EAST TOWN CROSSING FRONTAGE IMPROVEMENTS

COVER SHEET

EAST TOWN CROSSING SHAW ROAD IMPROVEMENTS

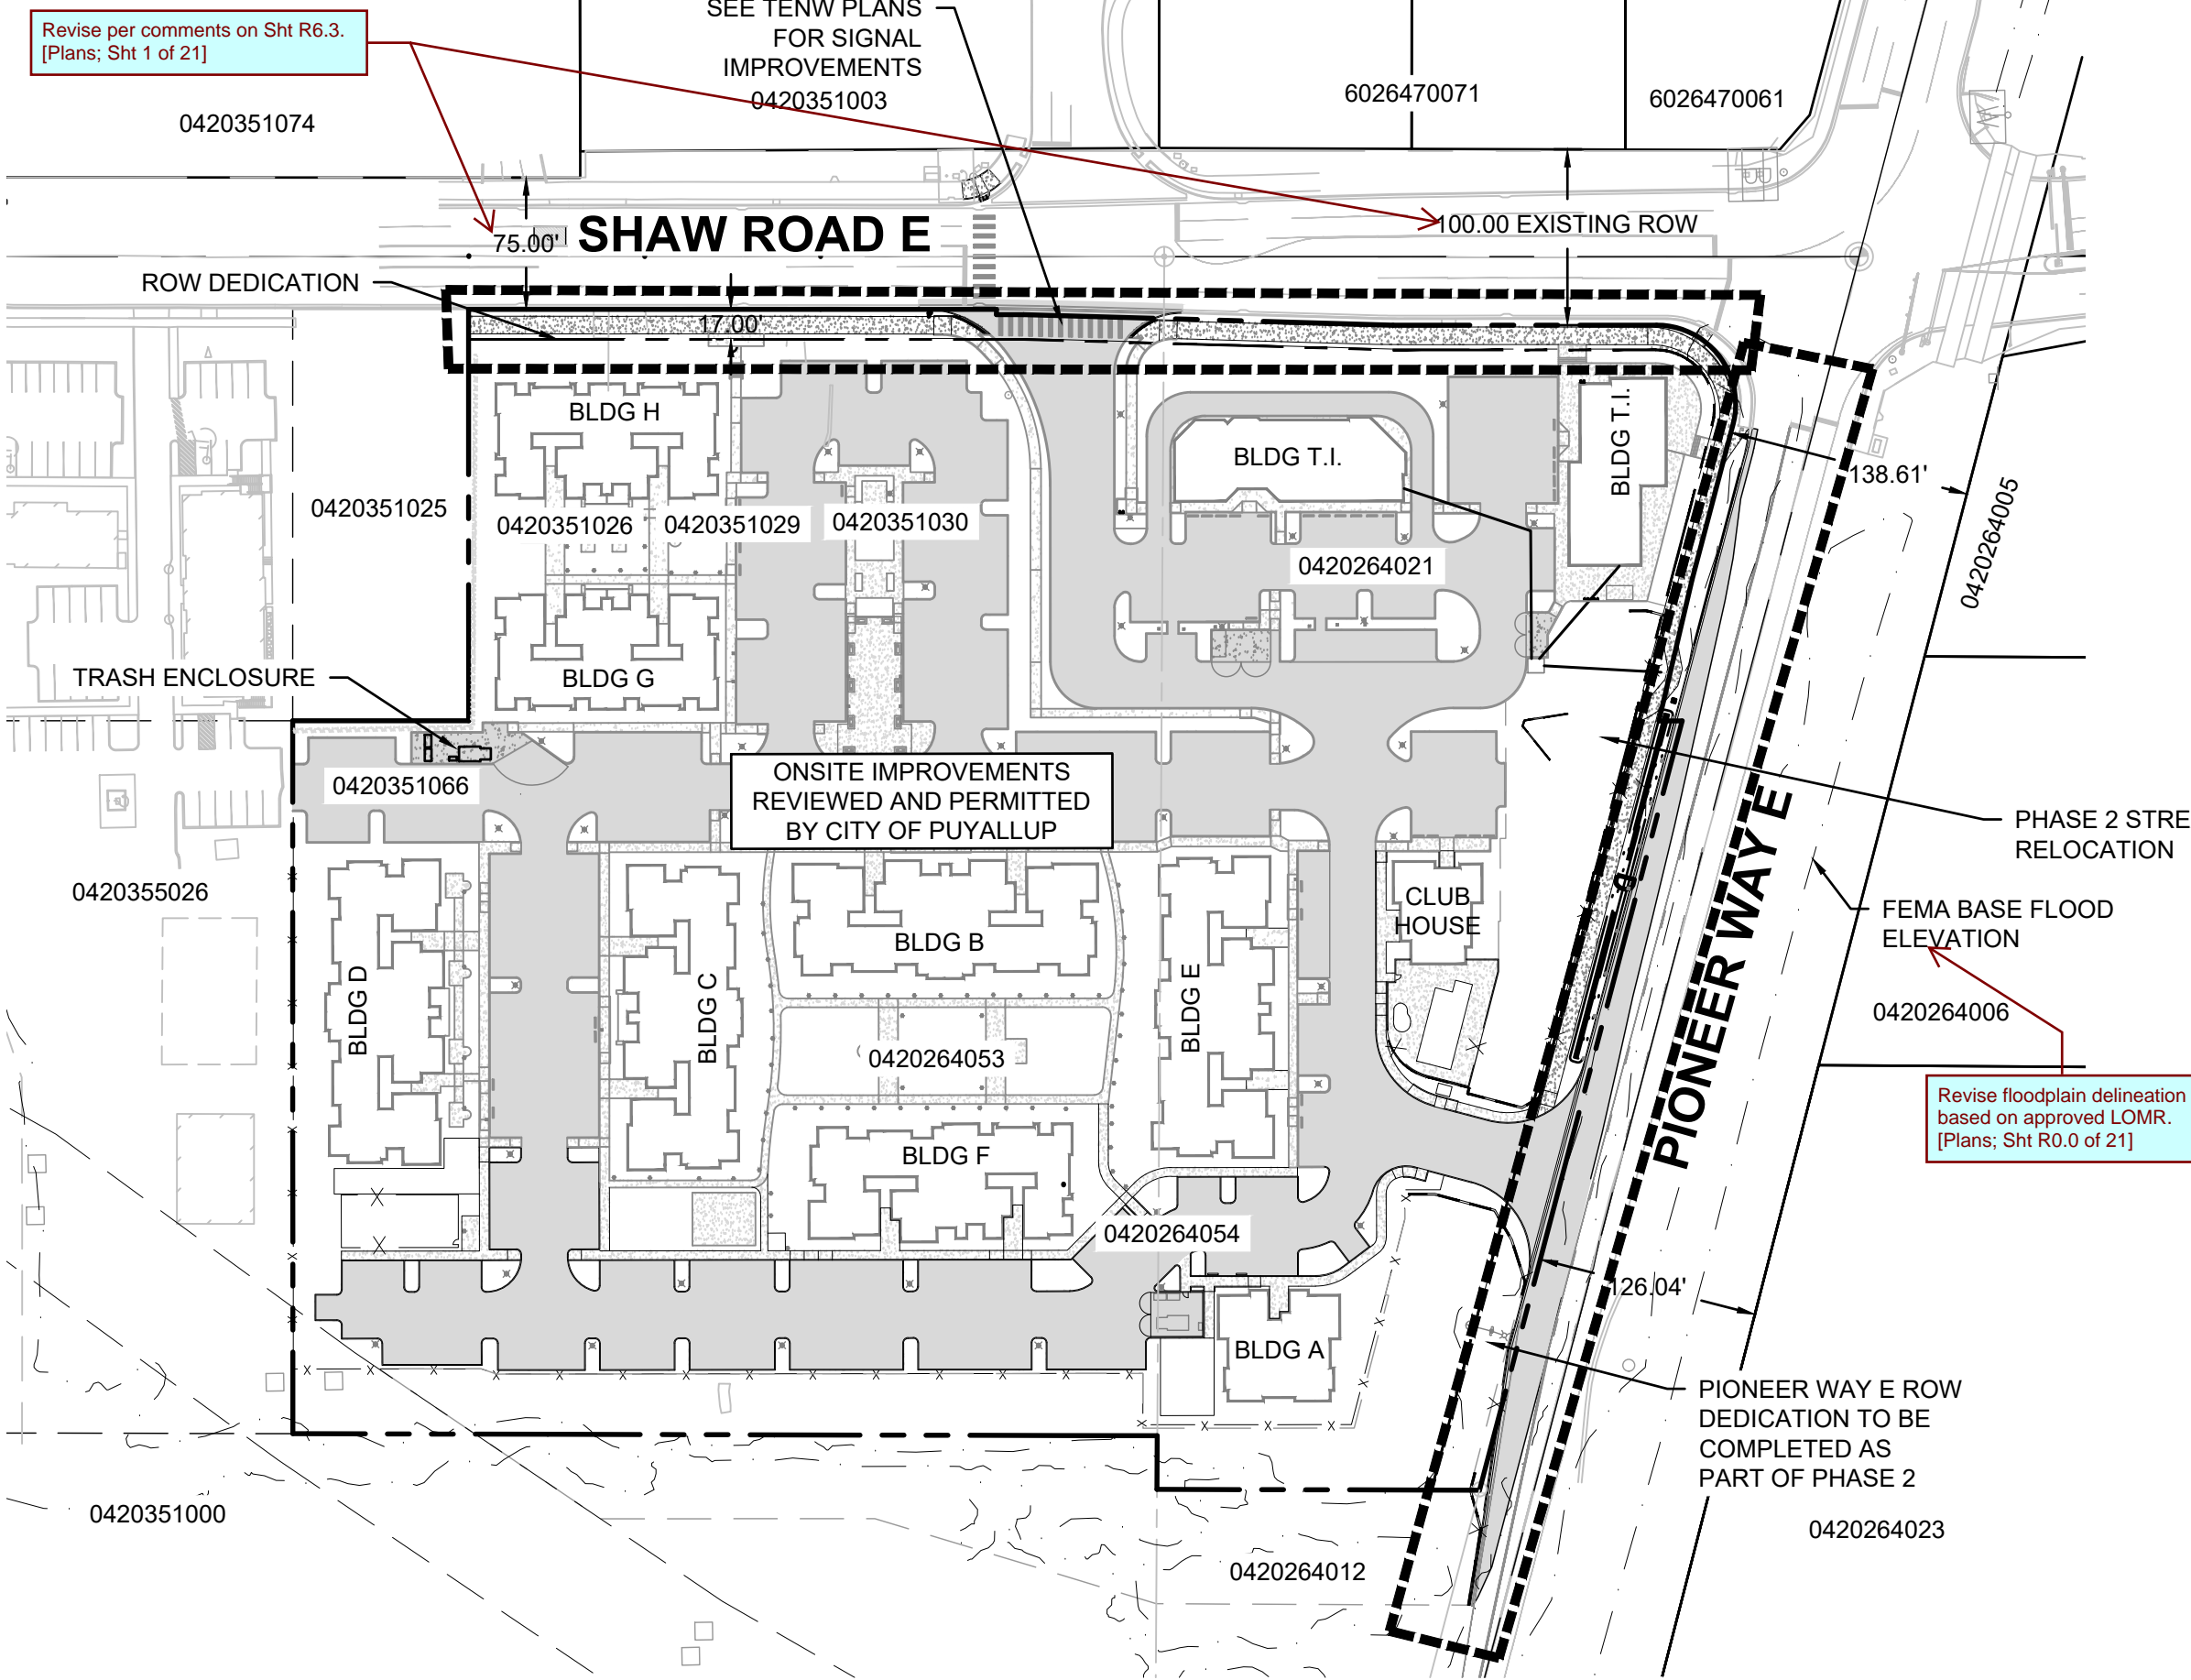
Provide DRAFT ROW dedication deed along Pioneer Way frontage, including sketch, on City Form. 34th road width from centerline, 10ft planter, and 8ft sidewalk. Once approved, record with the Pierce County Auditor. [Plans: Sht R0.0 of 21]

Sheet Title:
**SHAW ROAD E TESC
AND DEMOLITION
PLAN**

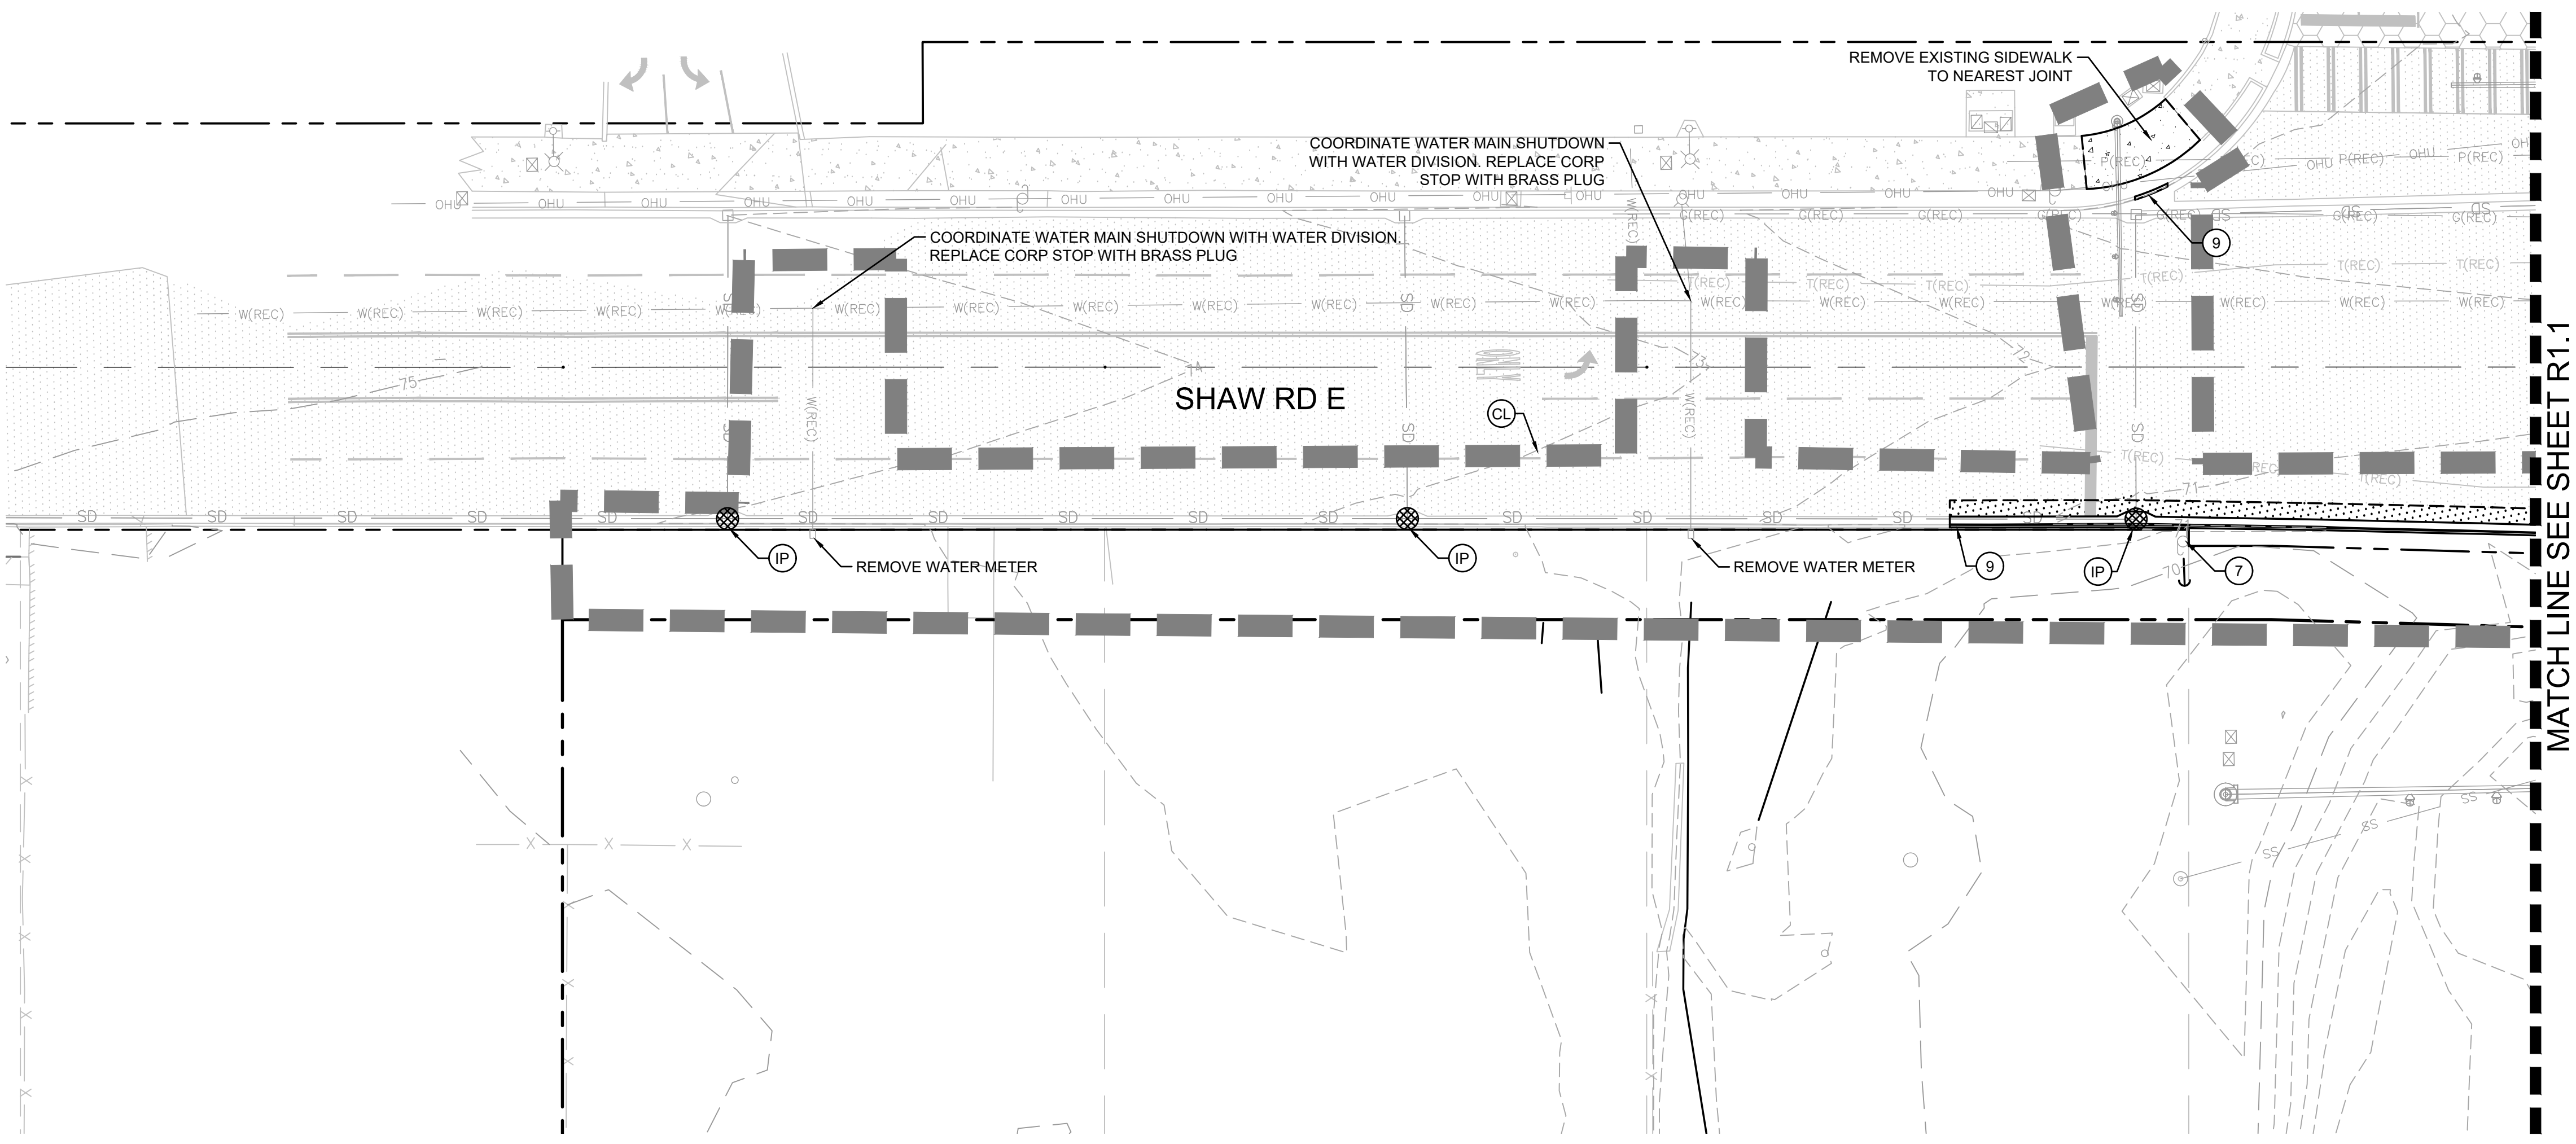
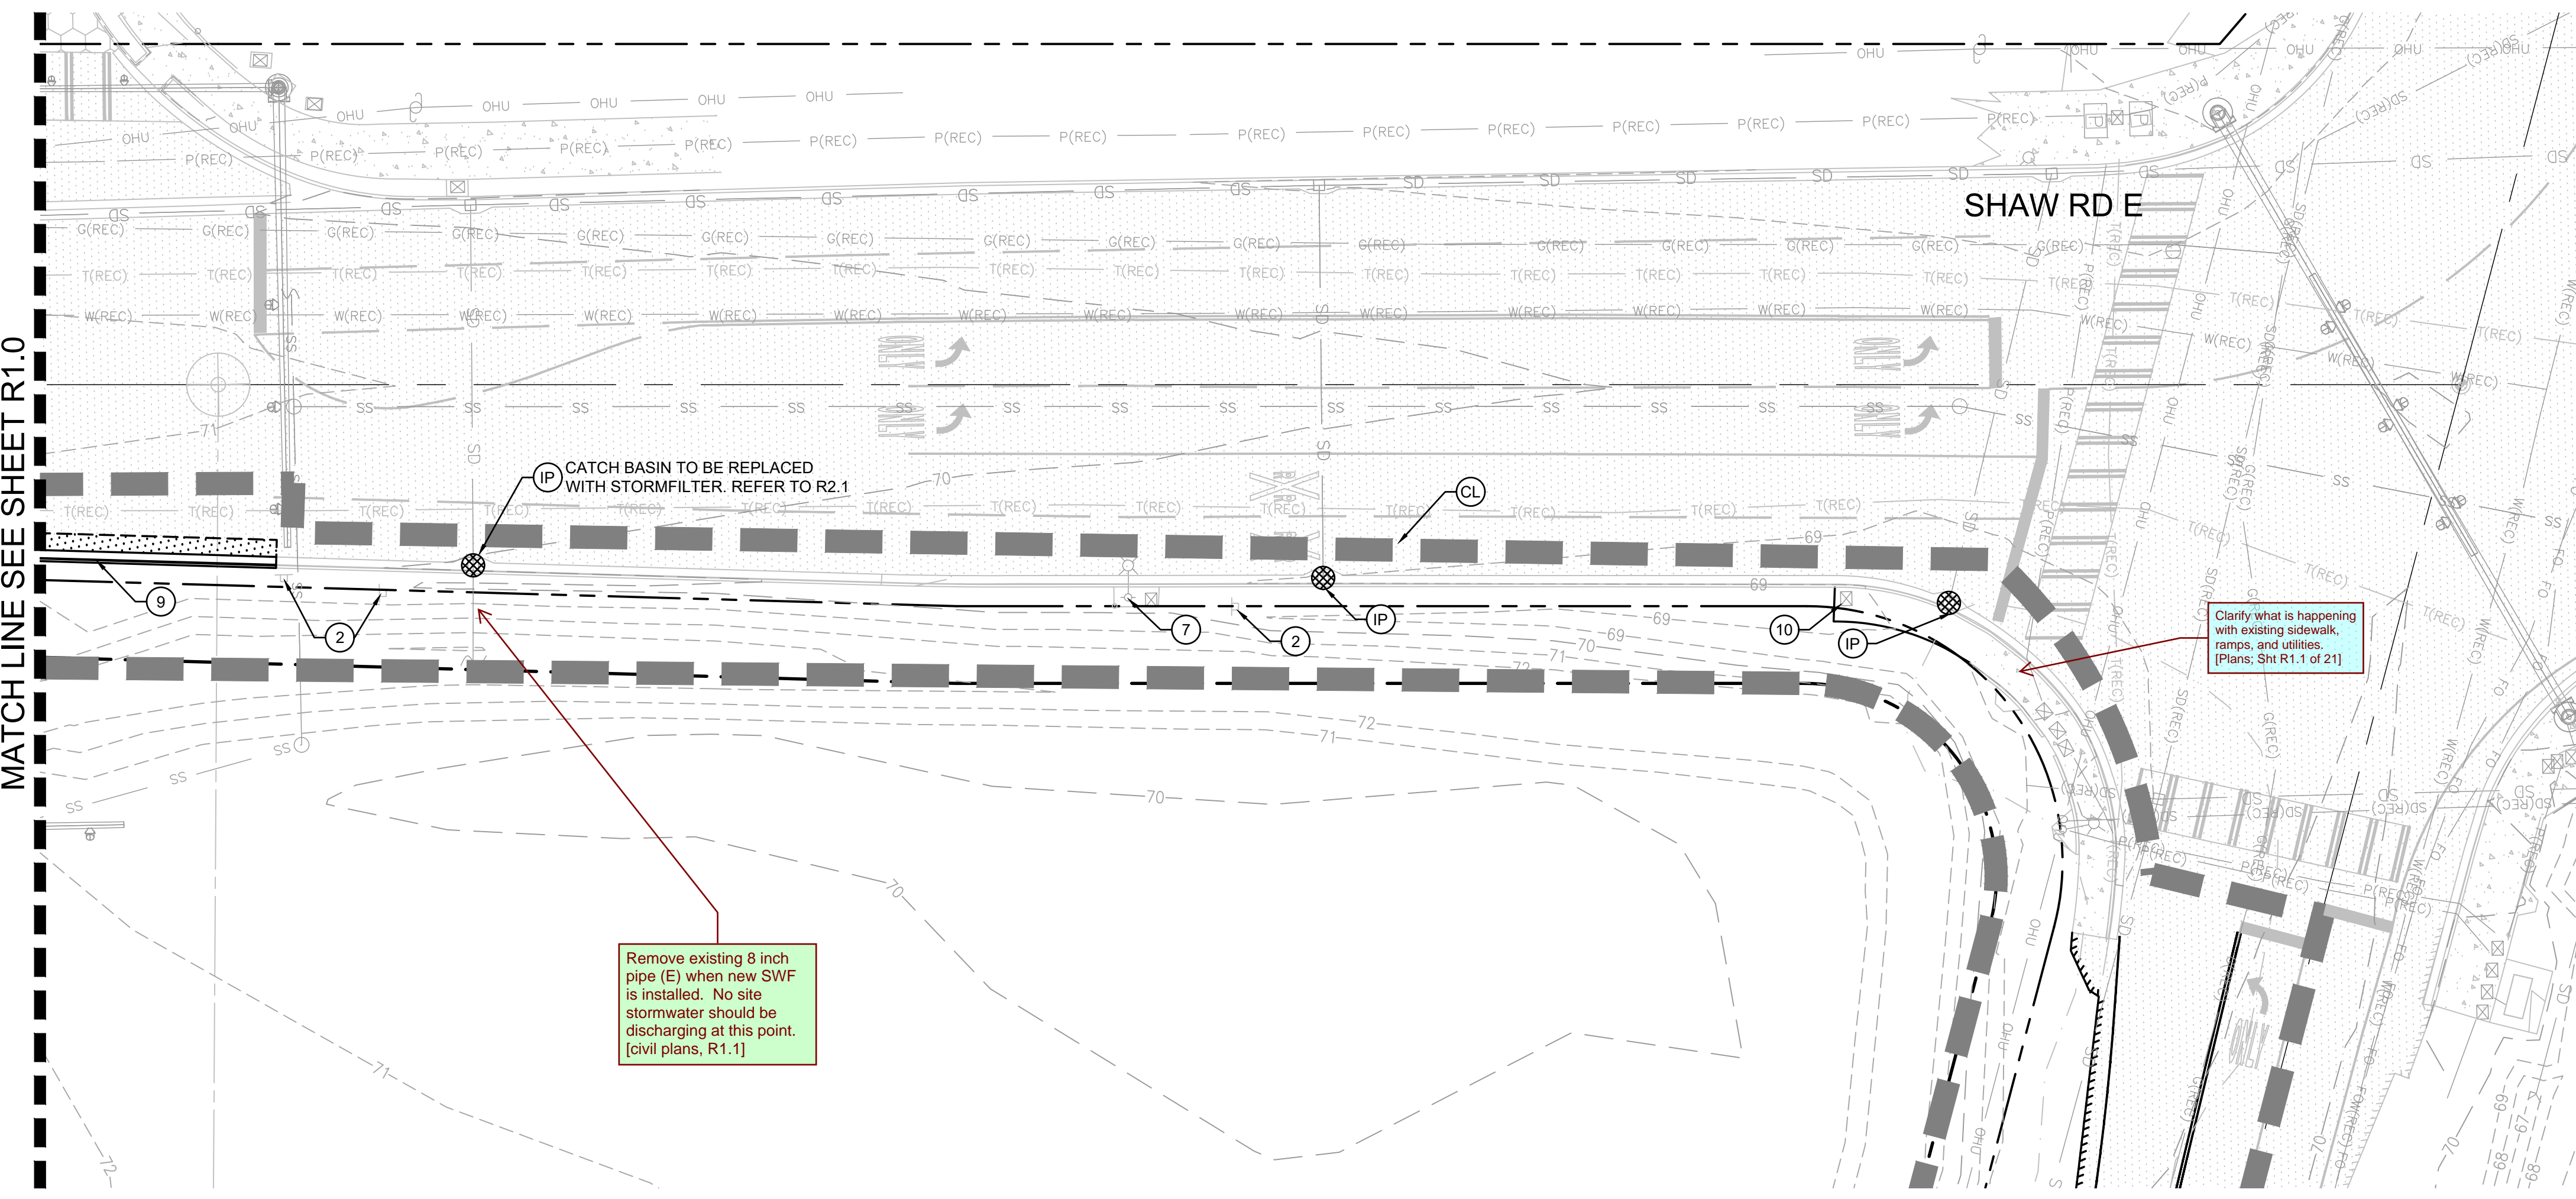
Add the following notes to the planset:
-Existing public utilities that are in conflict with proposed frontage improvements shall be relocated as necessary to meet all applicable City, State, and Federal requirements.
-Existing private utilities (power, gas, telcom, cable, etc...) that are in conflict with City maintained right-of way and utilities shall be relocated outside of the travelled road section, i.e., behind the curb under the sidewalk area or other location as approved by the City.
[Plans: Sht R1.0 of 21]
